HORSHAM DISTRICT COUNCIL CONSULTATION

TO:	Horsham District Council – Planning Dept
LOCATION:	Land at Lower Broadbridge Farm Billingshurst Road Broadbridge Heath Horsham
DESCRIPTION:	Reserved matters application for the erection of 133 dwellings following approval of outline application DC/22/1052 as amended by DC/25/1886, relating to appearance, landscaping, layout and scale.
REFERENCE:	DC/26/0592
RECOMMENDATION:	Advice / No Objection / Objection / More Information / Modification / Refusal
SUMMARY OF COMMENTS & RECOMMENDATION: My main comments relate to the play area: 1) segregated nature of the play area and the need to integrate it into the surrounding landscape in a more fluid way 2) more challenge needed 3) safety surface needs amending 4) provision for youth

SB8132 - Castor Climbing Net

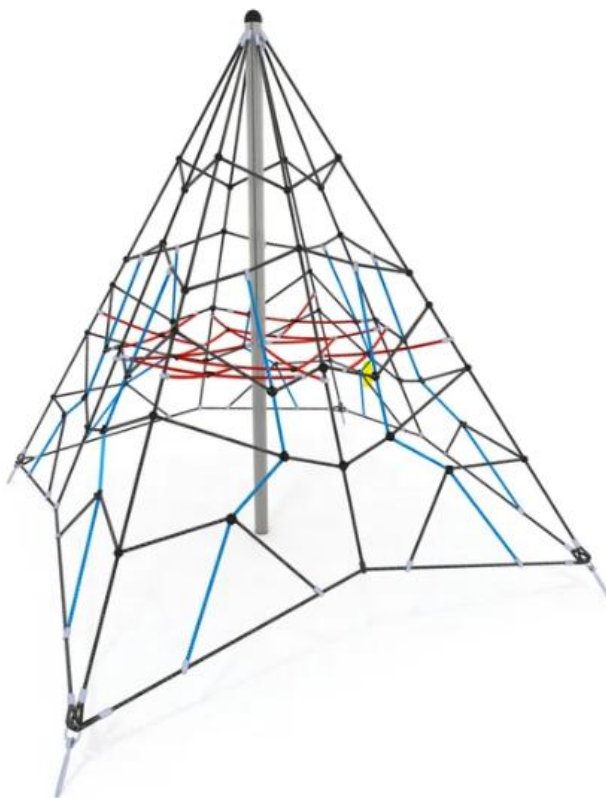
There isn't much opportunity for children to develop their skill and confidence in the play area. The balance beam is quite quick and easy to master. It really needs a more multi-dimensional climbing unit which allows gives children the opportunity to improve their ability. A climbing net would be a great feature to add in – it allows for traversing at the beginning, progressing to climbing to different levels and the additional bonus of being a central feature for climbing games and Floor is Lava.

This example by Miracle Play would be an appropriate size structure for the play area:
